AMENDMENTS TO THE DRAWINGS

App No.: 10/594,009 Docket No.: 1163-0584 Inventor: Kenichi MIYAGUCHI et al. Title: PHASE-SHIFTING CIRCUIT AND MULTIBIT PHASE Docket No.: 1163-0584PUS1

SHIFTER

ANNOTATED SHEET

FIG.6

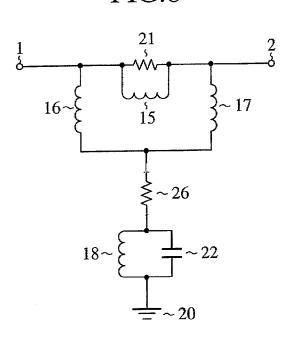
Applicants provide herewith a replacement drawing sheet for Fig. 6 to correct the unintentional omission of element 20 which is the ground (GND) which is similarly shown in Fig. 7, should be also included in Fig. 6. Accordingly, Applicants have provided a replacement drawing sheet for Fig. 6 attached herewith.
